Versa-Pac SAR Amendment

NRC Meeting
February 16, 2021

Discussion Outline

Addition of 5-inch Pipe With Limited Hydrogenous Packing Material

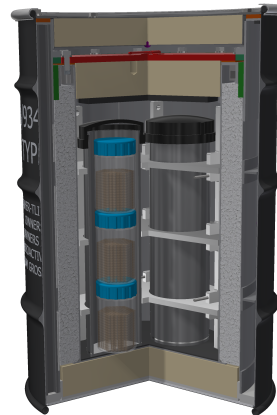
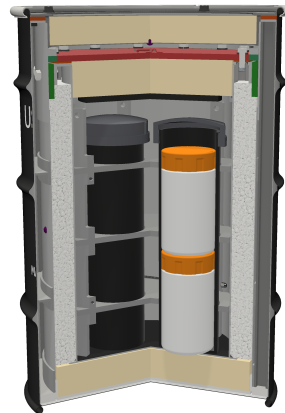
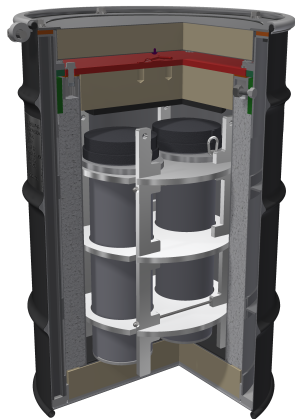
- Utilize current licensed 5-inch pipe component and allows up to 2 pipes per Versa-Pac to overcome volume limitations.
- Shoring components will be used for the 5-inch pipe(s) in practice, but not required.
- Current content addition covers 10 wt% (2 pipes per package) and 20 wt% (1 pipe per package) contents.
- No fissile material limit - contents limited to volume of the pipe(s).
- Hydrogenous materials limited to 1.25 lbs (567 g) per pipe. The basis for this limit is to allow for bio-bottles (2 orange lid or 3 blue lid per pipe), but these are not credited or required for the configuration.

➤ Licensing Drawing Changes

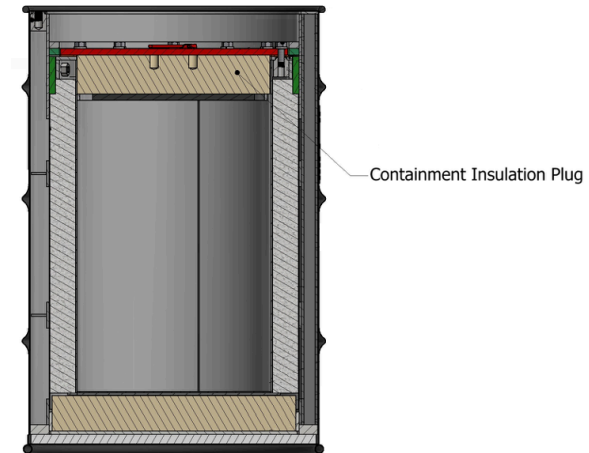
- Add note to list Containment Insulation Plug (IG), Containment Plug Retaining Bars (BF), and Bumper Pad (GE) as optional for temperature insensitive contents (e.g., TRISO compacts).
- Revise note 10 to allow tolerance for drum lid gasket GA thickness.

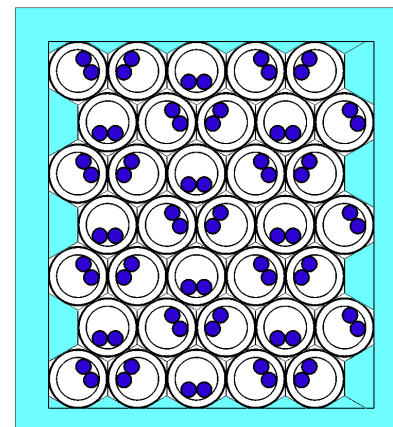
- **Chapter 6 Changes – 5-inch Pipe with Limited Hydrogenous Packing Material**
 - Covers 10 wt% & 20 wt% enrichments, hydrogenous packing materials limited to 1.25 lbs in each pipe.
 - 10 wt% cases allow unlimited fissile material permitted in two pipes
 - Uranium Oxide material CSI=1.0, other compounds CSI=1.4
 - 20 wt% case allows unlimited fissile material permitted in one pipe
 - All compounds have CSI=1.0

➤ Chapter 6 Changes –5-inch Pipe with Limited Hydrogenous Packing Material

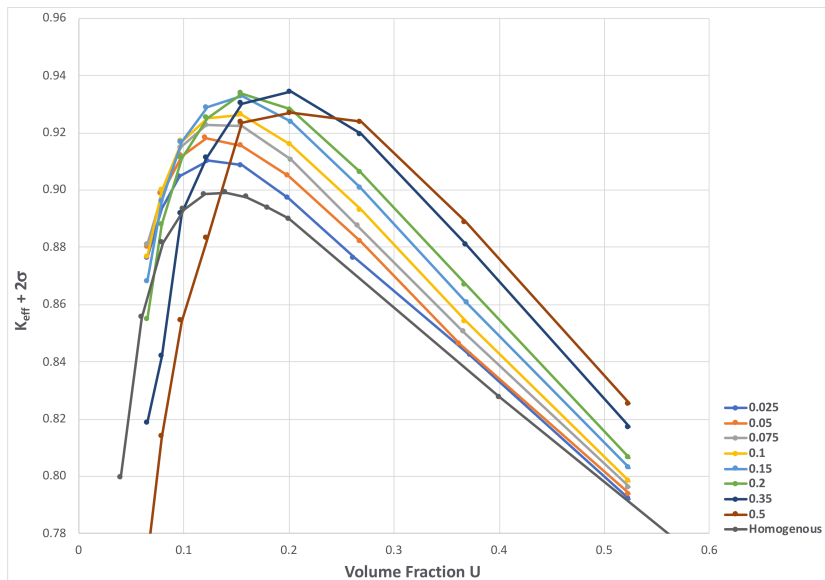
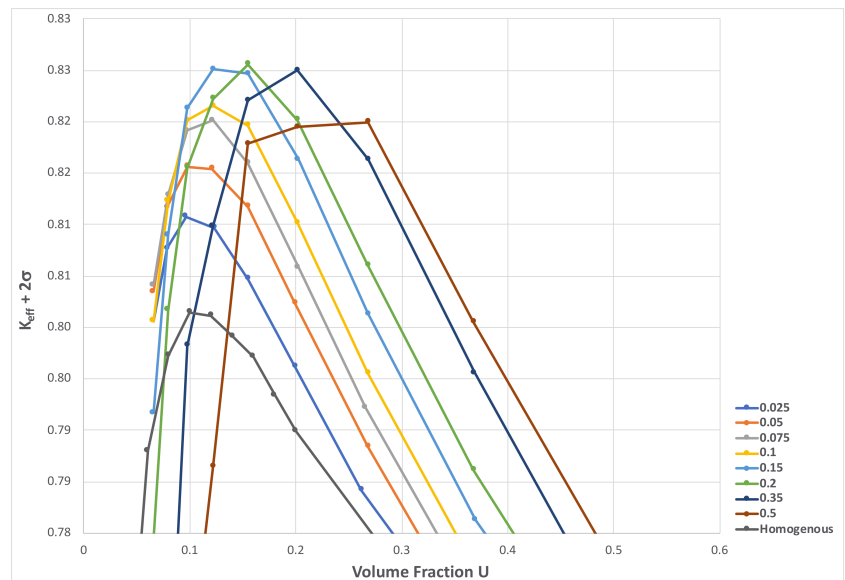
10 wt% HAC Array (U-Metal / CSI=1.4)

20 wt% HAC Array (U-Metal / CSI=1.0)
